# MISSION + CORTLAND

Signal Upgrade Switchover 3/21/00; 12/12/18 Rev.

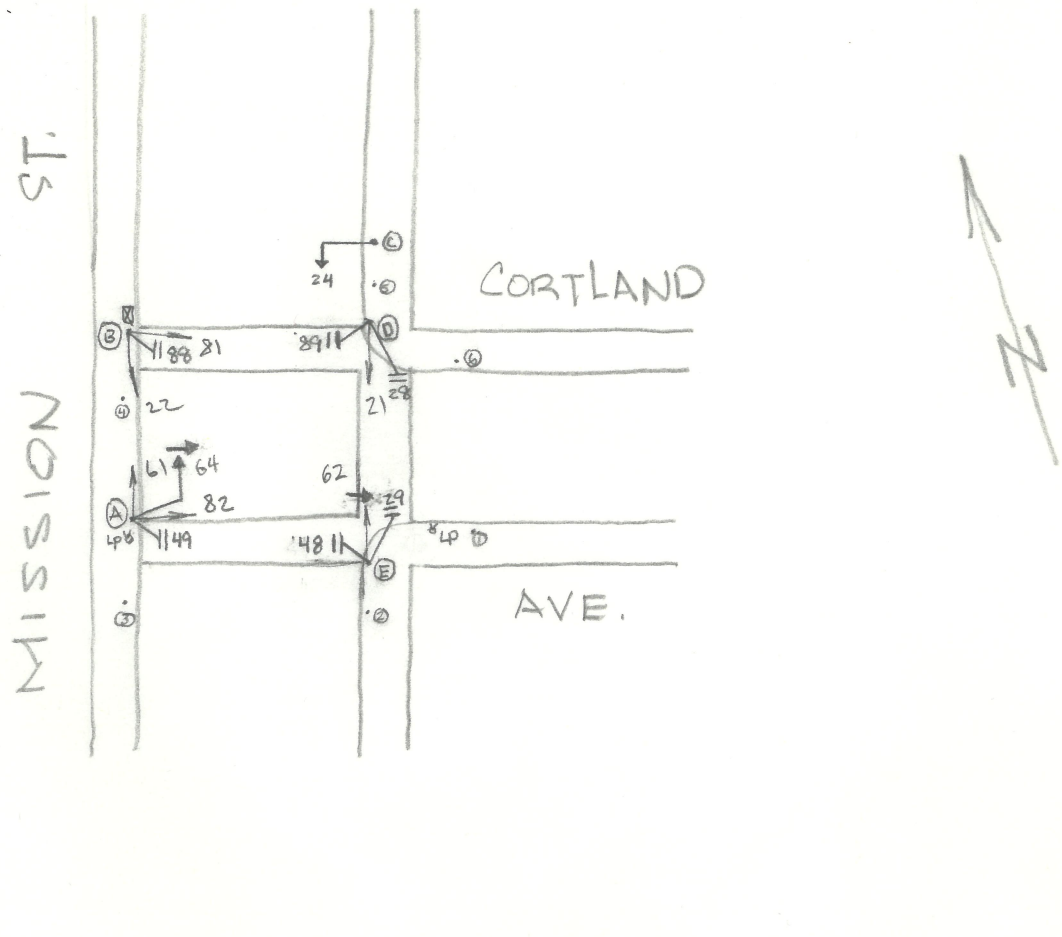
COMMENTS : REPLACED SIGNALS 62 & 64 WITH 4-SECTION WITH LEFT TURN ARROW. 62 UPGRADED FROM 8" TO 12". - A. LAM REPLACED 10' POLE E WITH 15' POLE. REV. PER SRC 2018-476. 11/27/18
